NOISE ANALYSIS

6029-002-122, PE 100

ERRATA - May 17, 1990

Route 29 Corridor Study
Noise Analysis Technical Memorandum dated April, 1990

Noise Site Locations

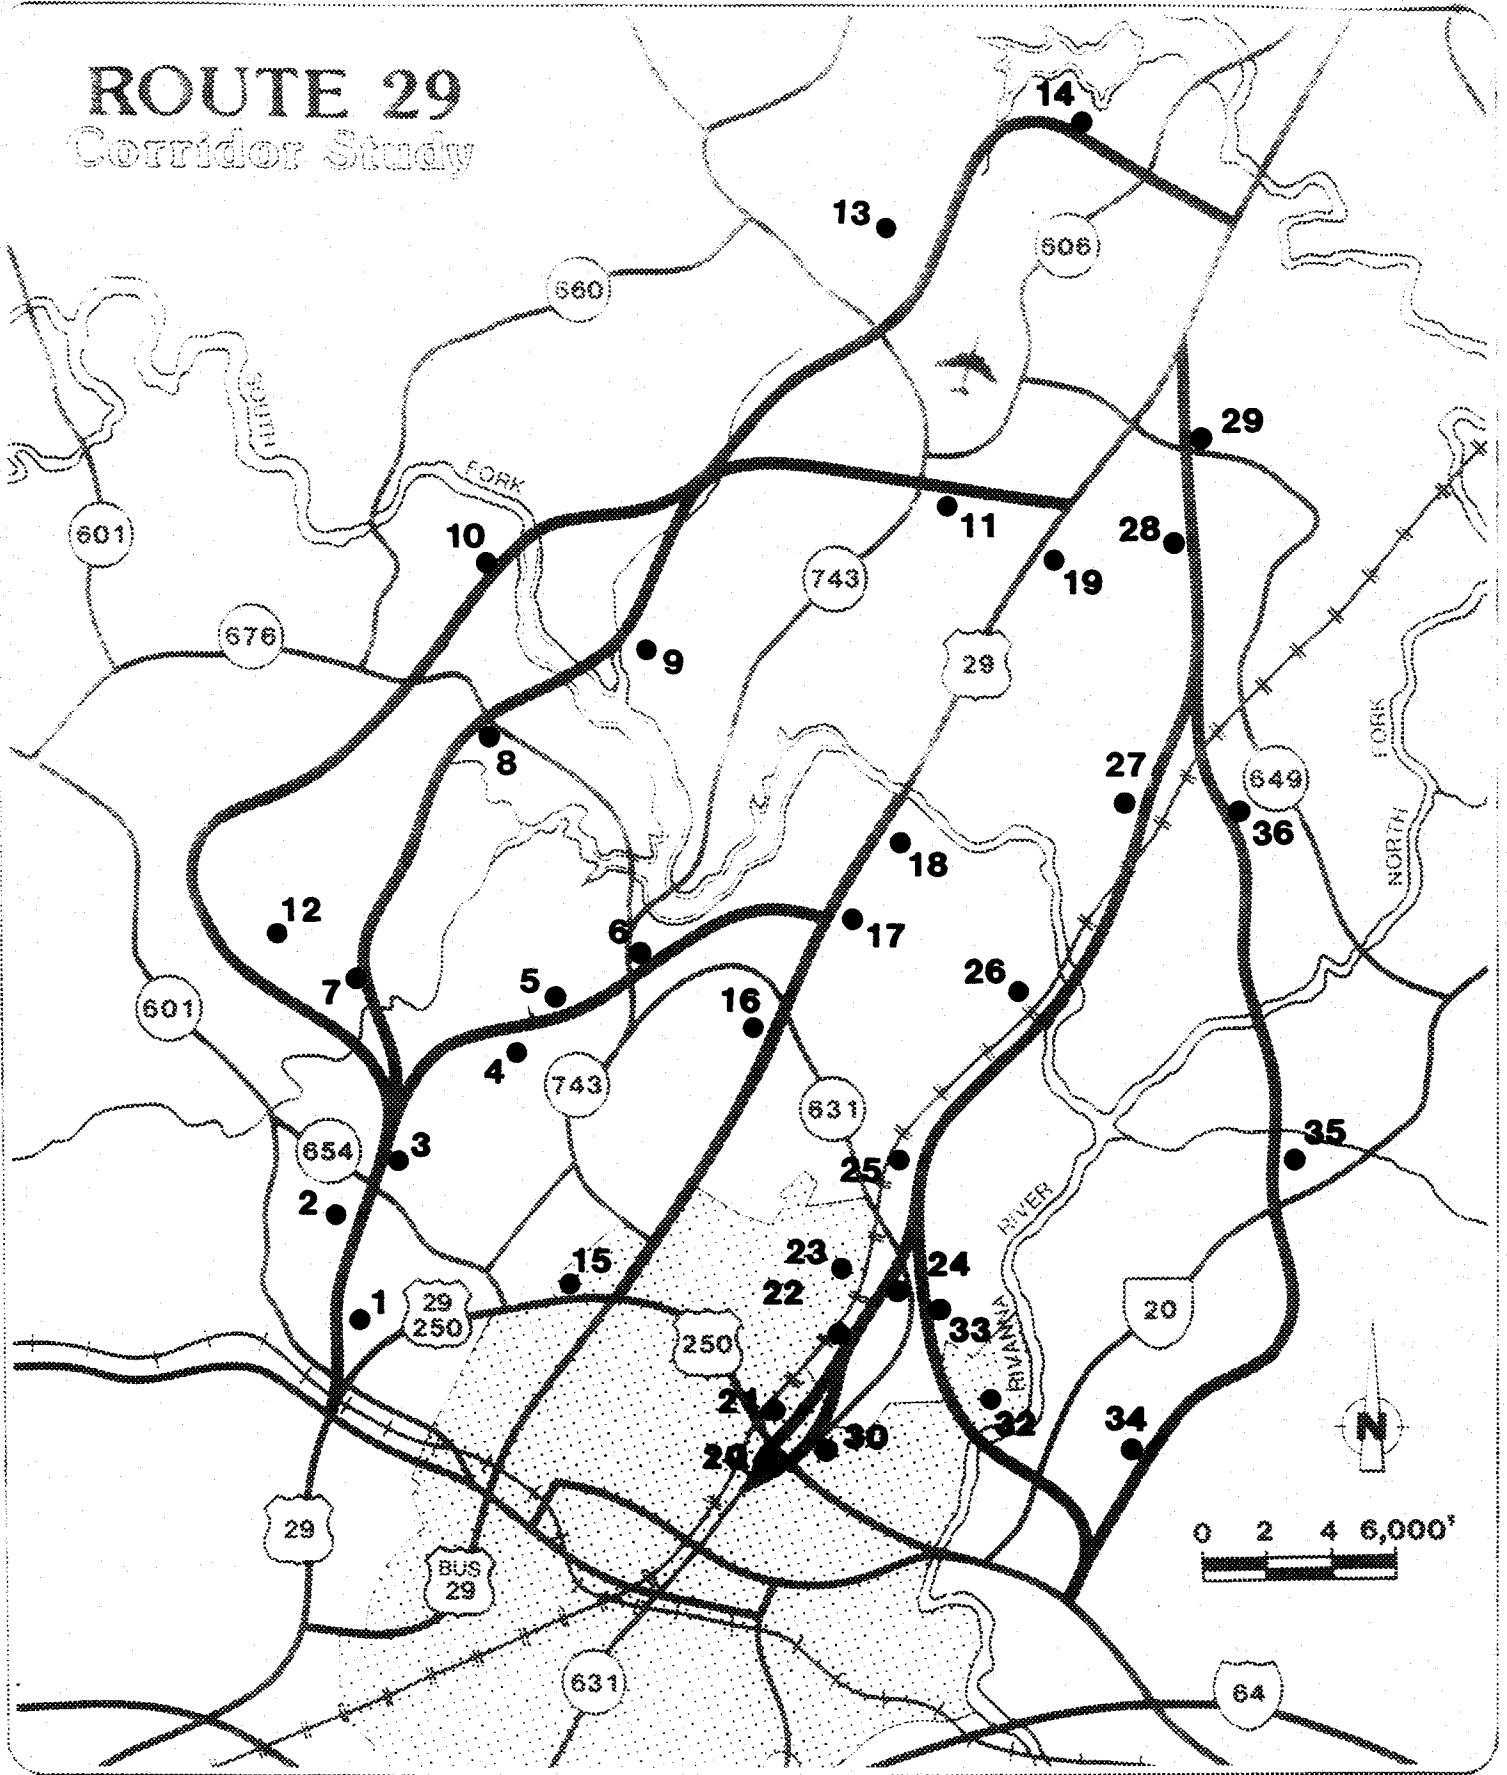
Figure 4

Site 1 should be on west side of Alternatives 10, 11, and 12 rather than east side.

**Potential Sound
Barrier Locations**

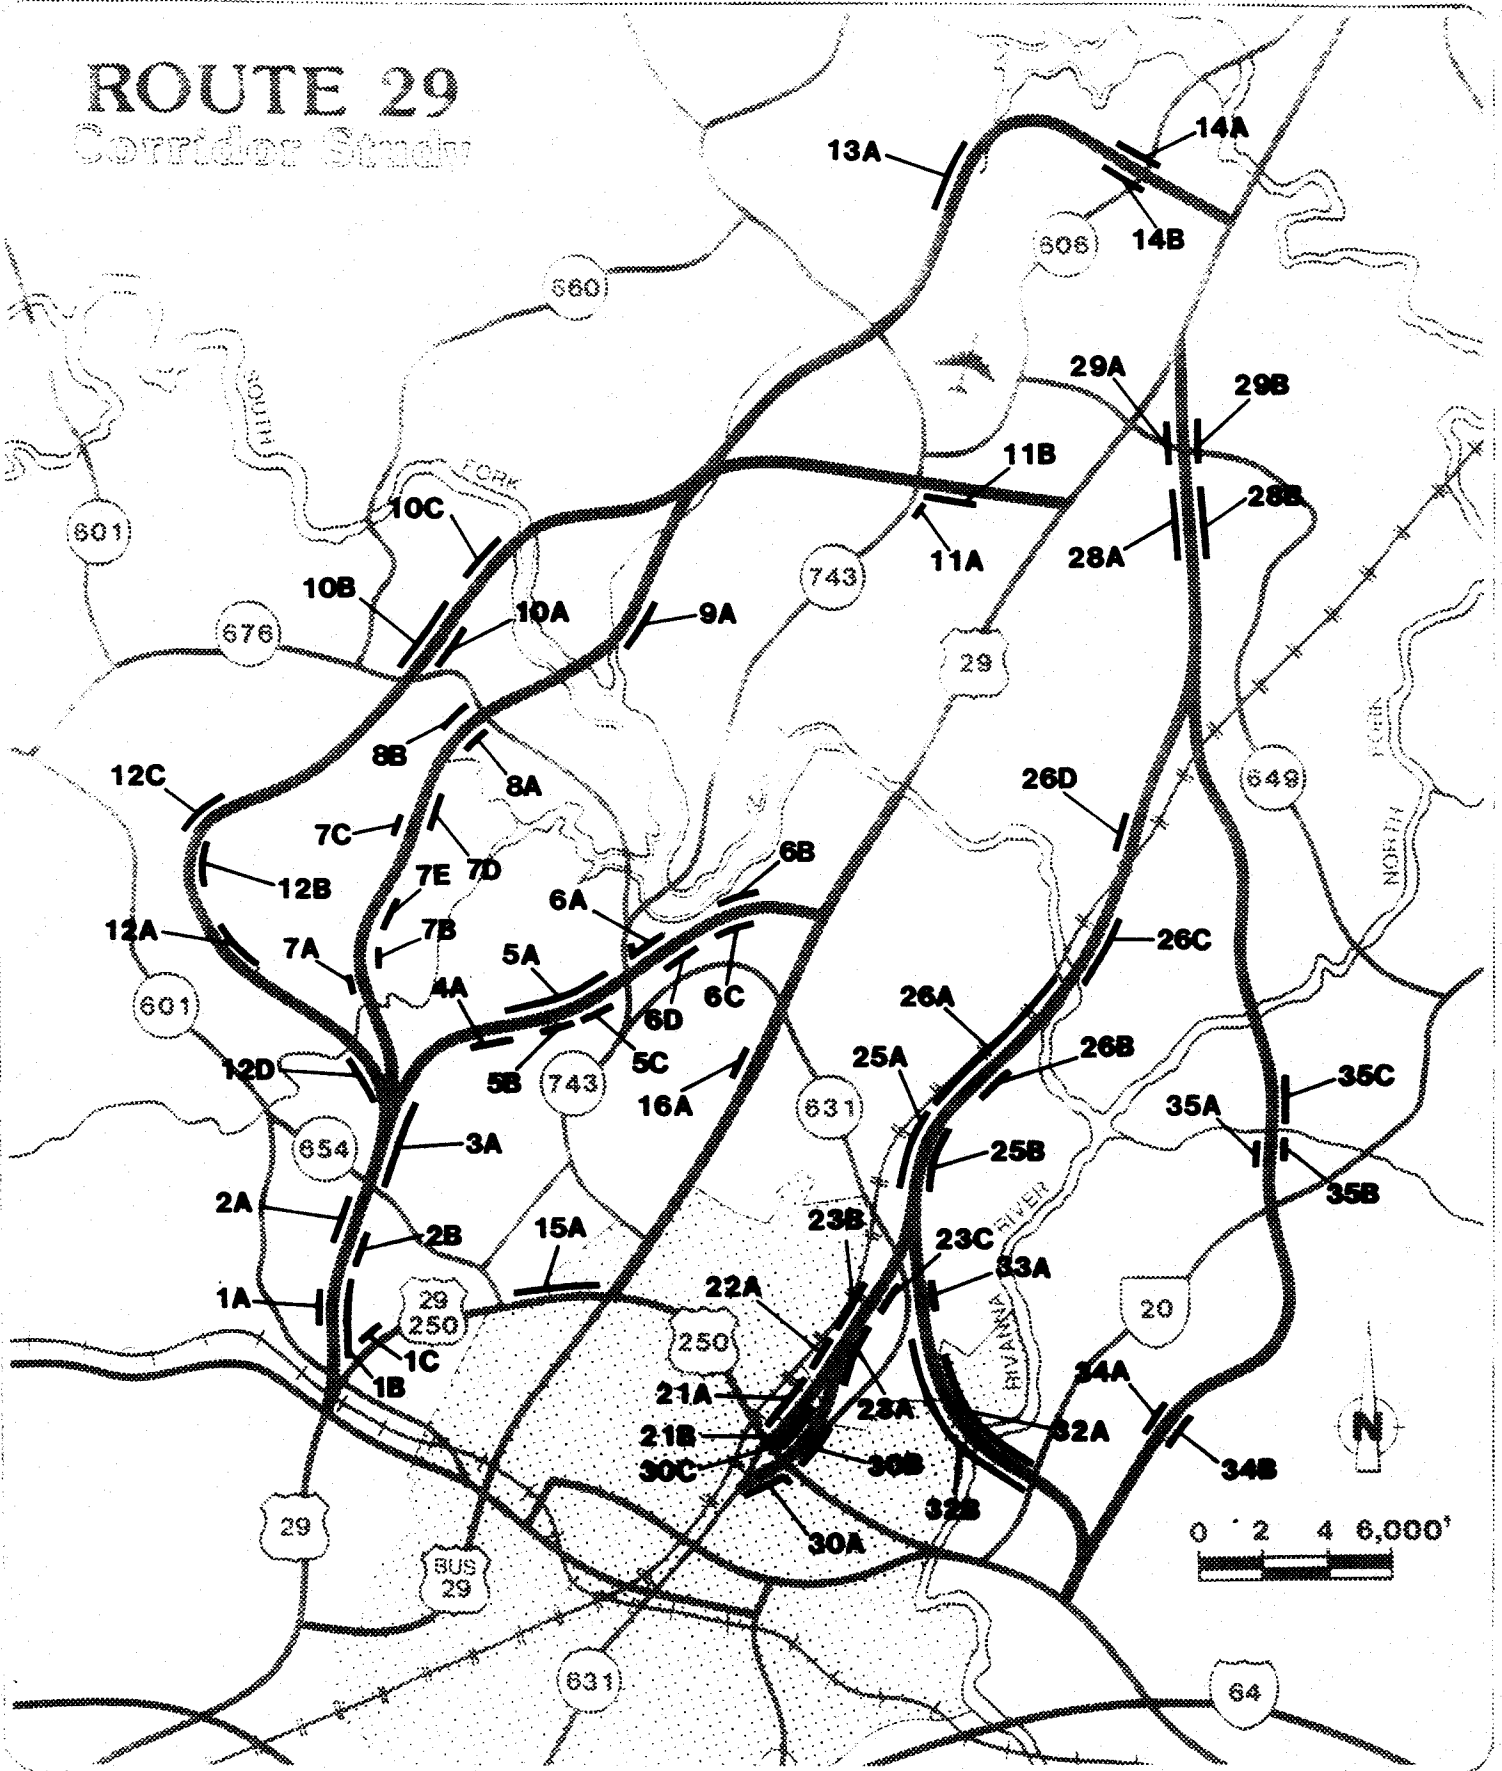
Page 60, figure 6.

Barrier 2B should be deleted.
